## SERVICE BULLETIN

**BULLETIN NUMBER:** SB-0054  
**REVISION:** 1-0-0  
**DATE:** JUN 2011

**PRODUCT DESCRIPTION:** CAUTION:  
30W VHF Amplifier – Transistor Change from Max 4W Input Power to Max 6W

**DE REFERENCE / ECO:** CO 6645

FIGURE 1

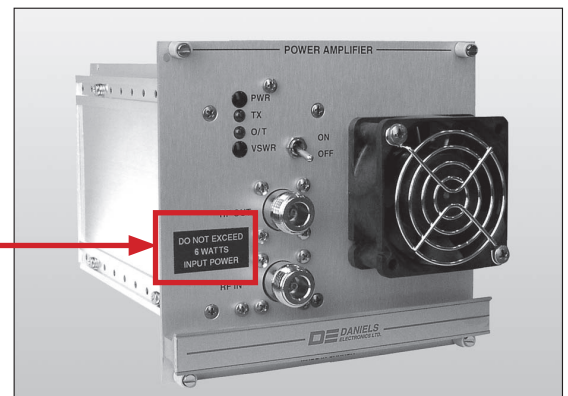
**PROBLEM:** The RF Transistor MRF646 used in the VHF 30W Power Amplifier is obsolete. A new transistor MRF1946 has been tested and provides acceptable performance in the 136–150 MHz, 150–162 MHz and 162–174 MHz bands.

Pre-CO amplifiers containing the obsolete MRF646 transistor require an RF Input Power of 2–4W. Amplifiers containing the new MRF1946 transistor require an RF Input Power of 2–6W. Concerns have been raised that users who have product with the obsolete transistor and also product with the new transistor may use a 6W input and blow the amplifiers requiring a 4W input.

**SOLUTION:** Look for the label on the front panel of the 30W VHF Power Amplifier. If the label reads “Do Not Exceed **6 Watts** Input Power” (see Figure 1), the amplifier contains the new transistor. The 6W model has unique alignment instructions and performance specifications. Refer to the manual, *IM71-001 VHF AMP-2 30W Power Amplifier Instruction Manual Version 2-0-0*, which was shipped with this model.
